FCC Class II Permissive Change for FCC ID: ZNFHBSSL6S

This is to request a Class II permissive change for FCC ID: ZNFHBSSL6S , originally granted on May 02, 2019 The device is identical to the previously certified LG STEREO Headset except for the modification following:

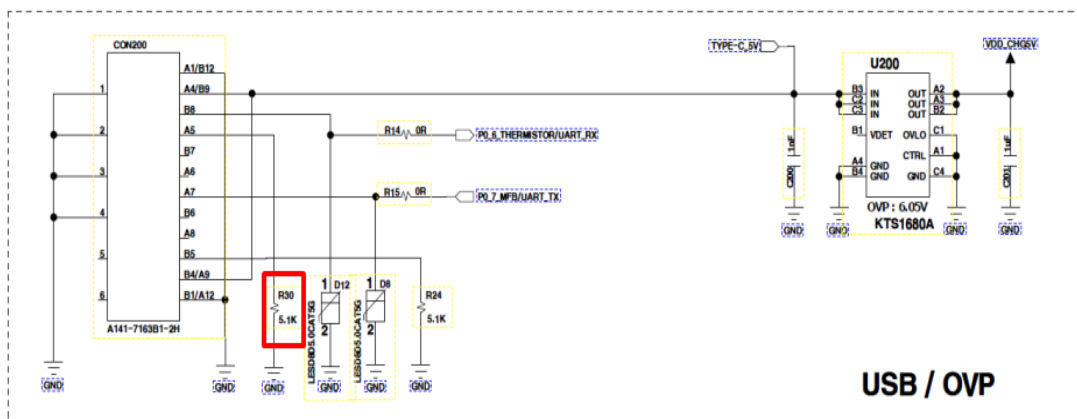
- Add Pull down resistor(R30, 5.1K) to improve reverse charging on TYPE-C adapters.

Before modification)

After modification)
